**SUBJECT:** **Customer Satisfaction Program 21B11 – Supplement #2**  
Certain 2014-2016 Model Year Explorer Vehicles  
2<sup>nd</sup> Row Inflatable Seat Belt

**REF:** **Customer Satisfaction Program 21B11 – Supplement #1**  
Certain 2014-2016 Model Year Explorer Vehicles  
2<sup>nd</sup> Row Inflatable Seat Belt

**New! REASON FOR THIS SUPPLEMENT**

## CERTAIN 2014-2016 MODEL YEAR EXPLORER VEHICLES — SECOND ROW INFLATABLE SEATBELT

**FIGURE 13**

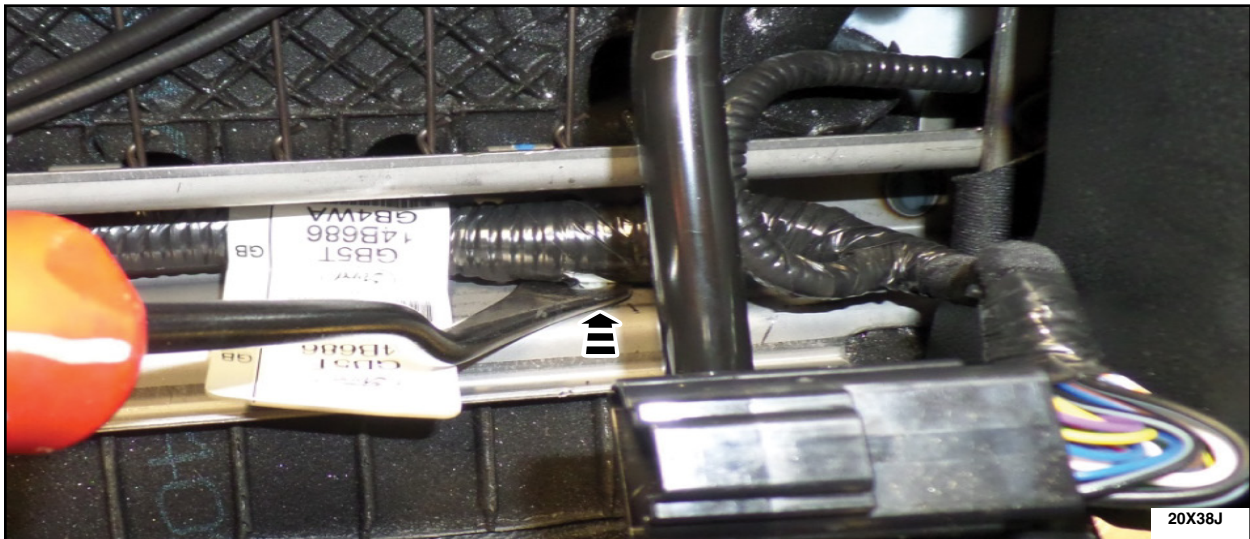
1. Disconnect battery cable to ground. Please follow the Workshop Manual (WSM) procedures in Section 414-01.
2. Remove the seat bottom cover from the affected seat. Please follow the WSM procedures in Section 501-10.
3. On the affected seat, disconnect the electrical connector and remove the connector and wiring harness pushpin from its mounting on the seat frame.
4. On the affected seat, follow the seat harness and locate the next harness retaining pushpin closest to the electrical connector and remove it. See Figure 13.

**FIGURE 14**

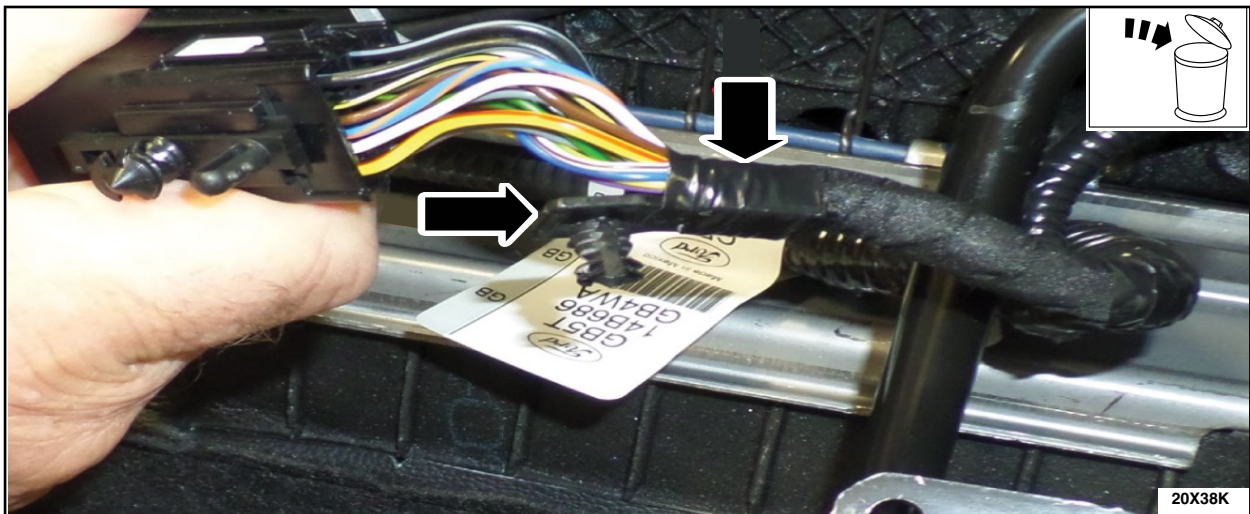
5. On the male side connector of the affected seat where the wiring harness is taped to the harness - pushpin retainers, remove the retaining tape and the harness pushpin. Discard the pushpin. See Figure 14.

**FIGURE 15**

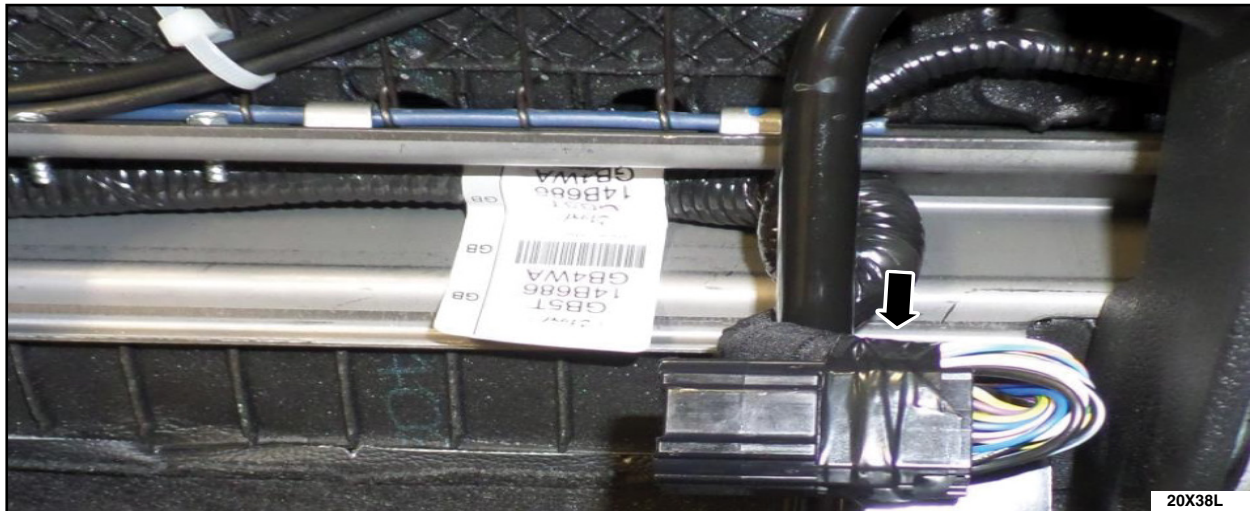
9. On the male connector create a 15-20 mm (1/2-3/4") loop with the wiring harness and secure the harness to the connector using electrical tape. Make sure the wire loop does not contact the seat trim. Wrap the harness and connectors 3 times to provide harness stress relief and to prevent damage to the connector terminals when the seat is folded forward. See Figure 15.
